Access Compliance Report

Public Rights-of-Way

Intersection ID: 49561	Main Street: ARTISTS_WY	Cross Street: SPENCER_ST	Location: NE
ADA ID: 2D96D93D283C	Ramp Type: Perp	Initial Pass/Fail: Fail	Overall Compliance: No
		Severity Score: 1.25

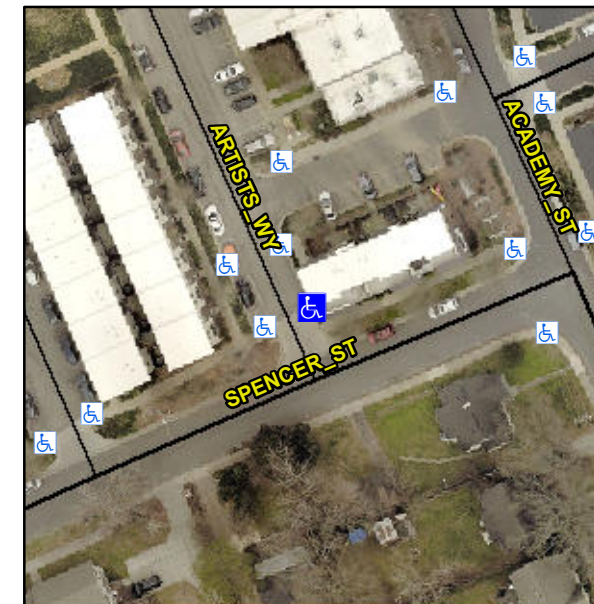
R304.5.3

Compliance	Description	Data	Compliance	Description	Data
N/A	Ramp Length (in)	36.0	Yes	Ramp Slope (%)	7.6
Yes	Ramp Width (in)	69.0	No	Ramp XSlope (%)	2.5
N/A	Flare Type LT	N/A	N/A	Flare Type RT	N/A
N/A	Flare Slope LT (%)	N/A	N/A	Flare Slope RT (%)	N/A
N/A	Flare Traversable LT?	N/A	N/A	Flare Traversable RT?	N/A
N/A	Landing Length (in)	N/A	N/A	DWS Provided?	N/A
N/A	Landing Width (in)	N/A	N/A	DWS Contrast?	N/A
N/A	Landing Slope (%)	N/A	N/A	DWS Length (in)	N/A
N/A	Landing X Slope (%)	N/A	N/A	DWS Full Width?	N/A
N/A	Landing Curb? (Y/N)	N/A	N/A	DWS Offset (in)	N/A
N/A	Shared Landing?	N/A			
N/A	Gutter Ponding?	N/A	N/A	Gutter Slope (%)	N/A
N/A	Gutter Lip Ht (in)	N/A	N/A	Gutter X Slope (%)	N/A
N/A	Painted X Walk1?	Yes	N/A	Painted X Walk2?	N/A
	X Walk 1 Direction	To SW		X Walk 2 Direction	N/A
N/A	X Walk 1 Width (in)	62.0	N/A	X Walk 2 Width (in)	N/A
	X Walk 1 Slope (%)	2.0		X Walk 2 Slope (%)	N/A
	X Walk 1 X Slope (%)	3.8		X Walk 2 X Slope (%)	N/A

Remove & Replace Entire Ramp.
